OFFICE OF RIVER PROTECTION

SUBMITTAL OF HANFORD FACILITY RESOURCE CONSERVATION AND RECOVERY ACT PERMIT MODIFICATION NOTIFICATION FORM 24590-LAW-PCN-ENV-17-012

**Hanford Facility RCRA Permit Modification Notification
Form 24590-LAW-PCN-ENV-17-012**

Hanford Facility RCRA Permit Modification Notification Form
Part III, Operating Unit 10
Waste Treatment and Immobilization Plant

SCALE: NONE
24590-LAW-M6-LOP-00002001
REV 1

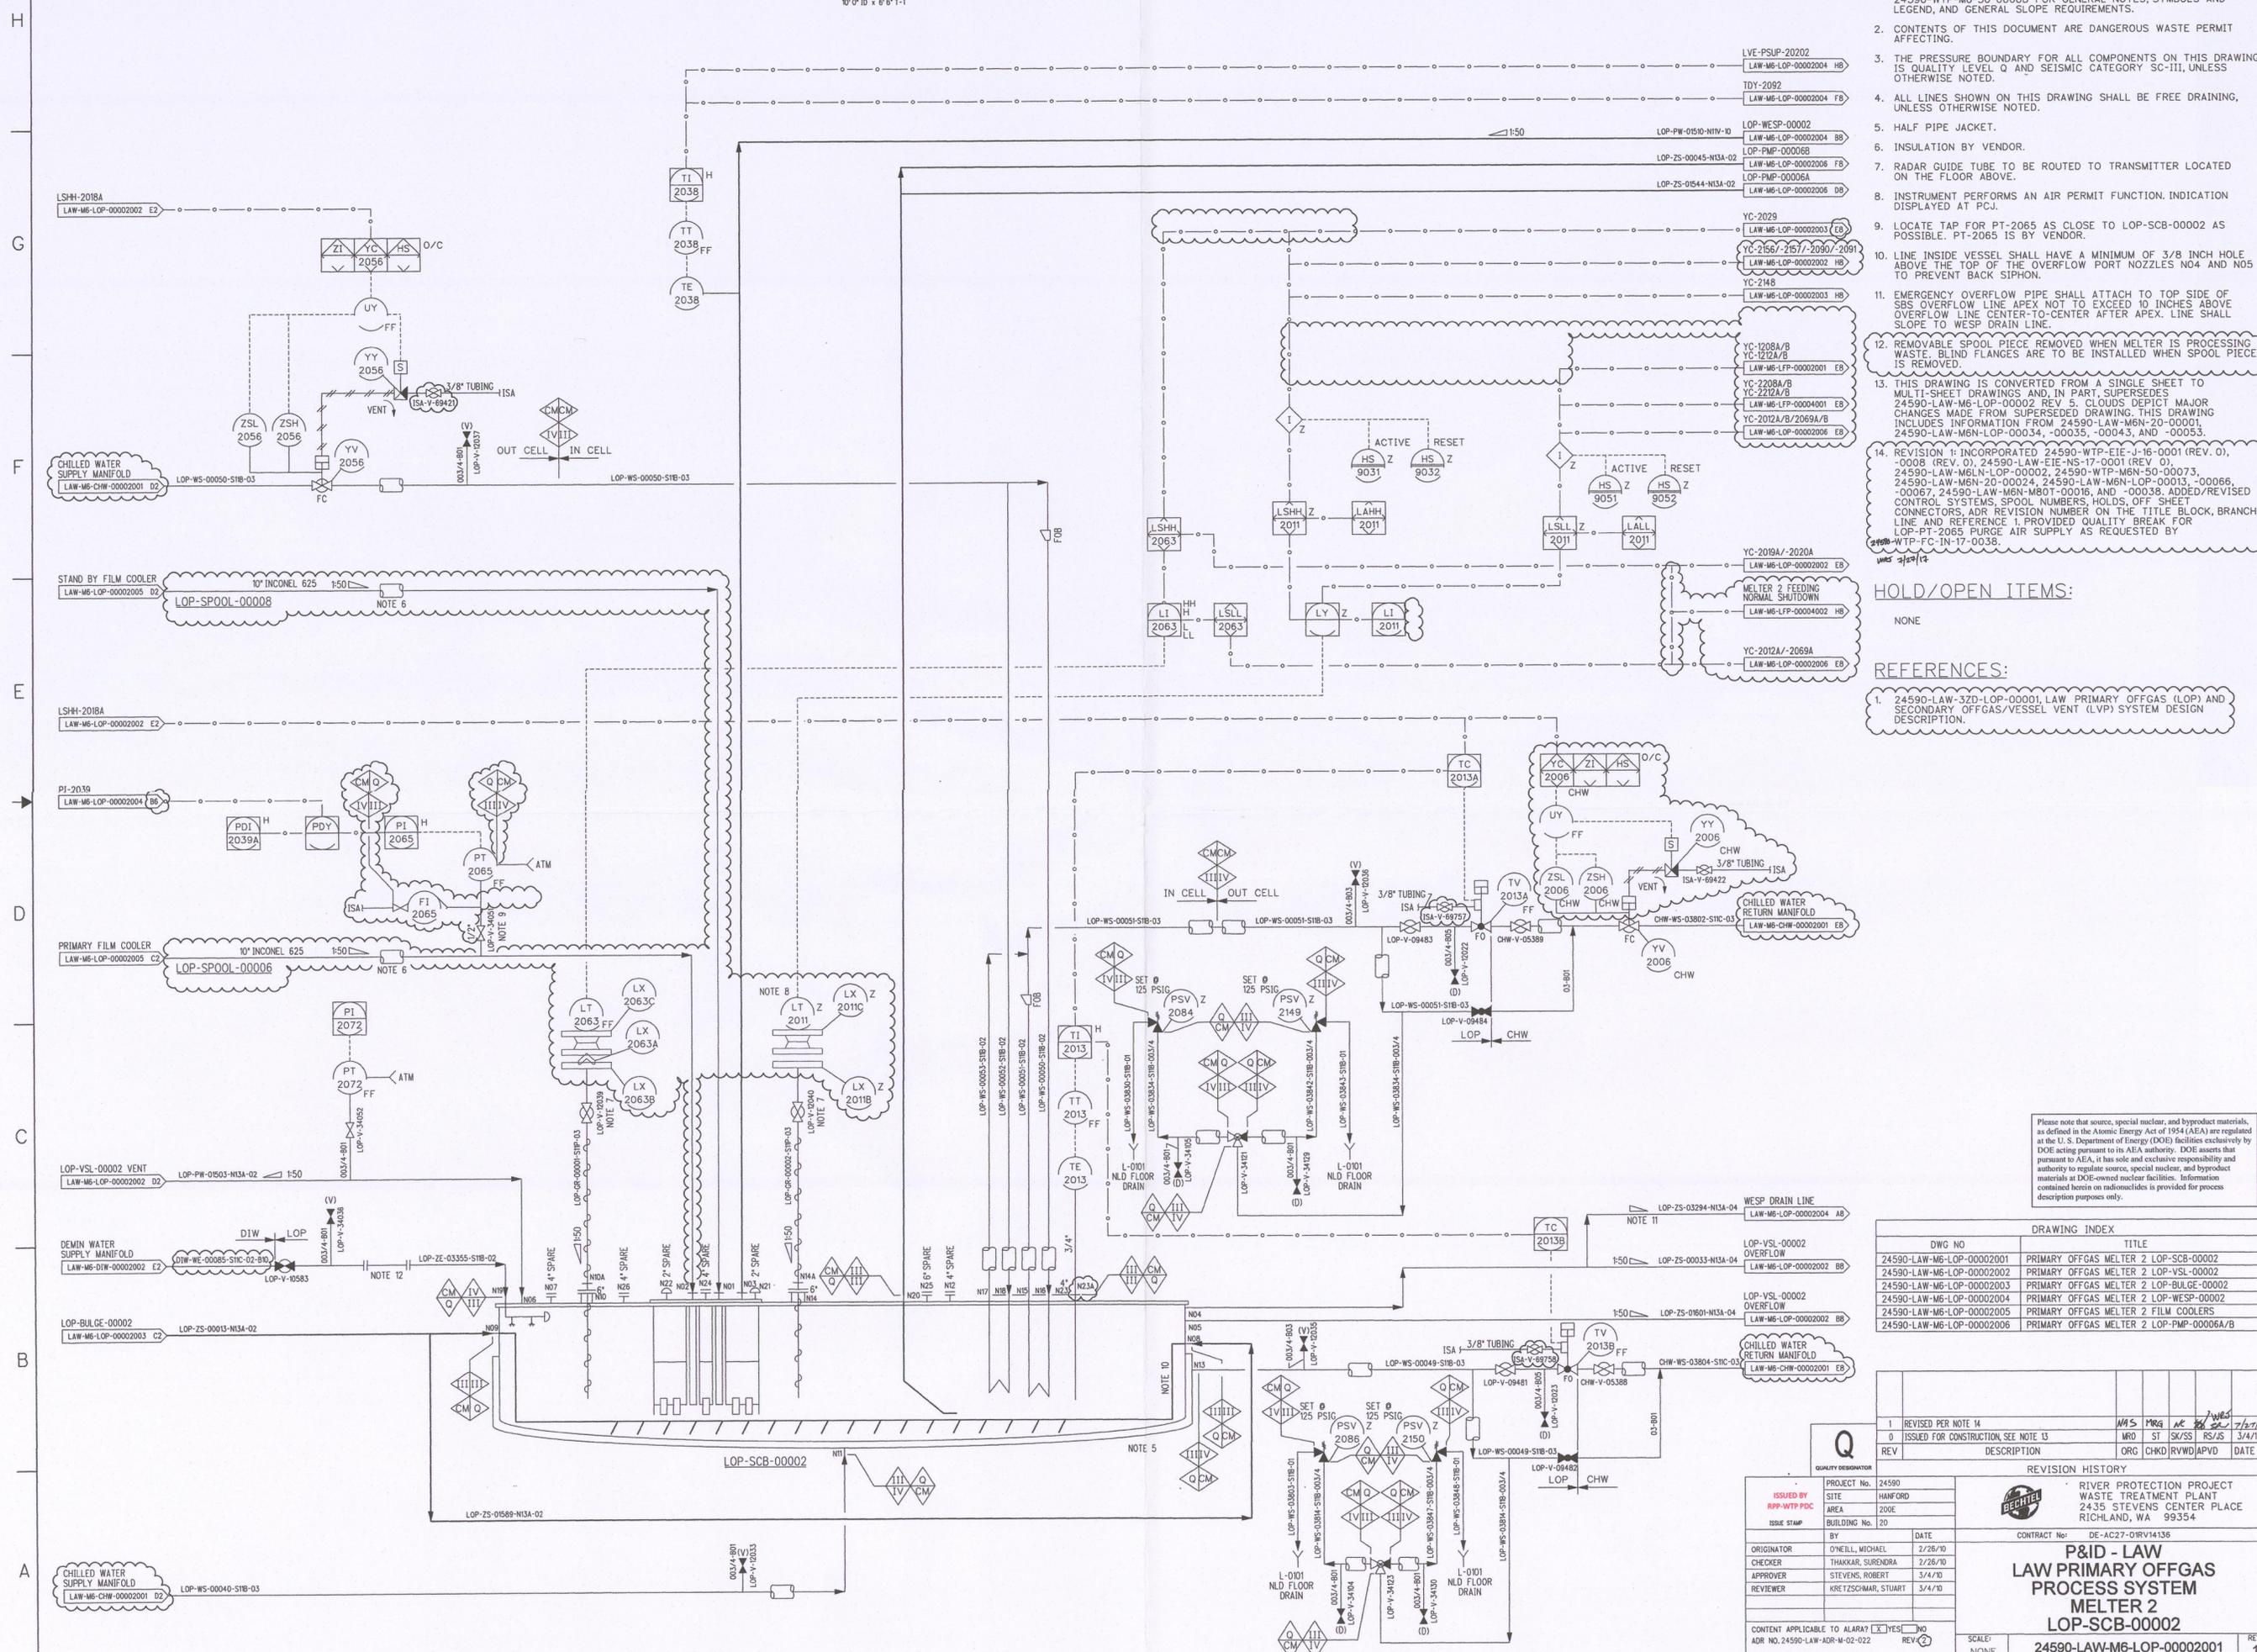
Changes to the P&ID (24590-LAW-M6-LOP-00002001, Rev. 1) for the Melter 2 Submerged Bed Scrubber (LOP-SCB-00002) are summarized below:

- Added or modified notes in the Notes section. Revised the References section.
- Revised graphical representation/depiction to correctly show the chilled water foundation fieldbus actuated valve YV-2006 (Grids D2 to D3 and E2 to E3).
- Revised graphical representation/depiction for remote radar level instrumentation LT-2011 and LT-2063 (Grid C6).
- Added tag number to purge air flow rate indicator (rotameter) FI-2065 (Grid D7).
- Enhanced the instrumentation and control presentation of level indicator LI-2011 (Grid E4) and added instrument line connecting level switch (high-high) LSHH-2063 and level switch (low-low) LSL-2063 (Grid E3).

- Changed valve symbol from gate valve to ball valve for ISA-V-69421, ISA-V-69422, ISA-V-69757 and ISA-V-69758 (Grids B3, D3 and F7).
- Changed diameter size of valve LOP-V-34051 from ¾" to ½" (Grid D7).
- Added nozzle N23A (Grid B5).
- Changed line number (DIW-WE-00085-S11C-02-B10) (Grid B8).
- Added, revised or deleted off-sheet connectors (multiple grids).
- Incorporated changes from change documentation identified in the Notes section.
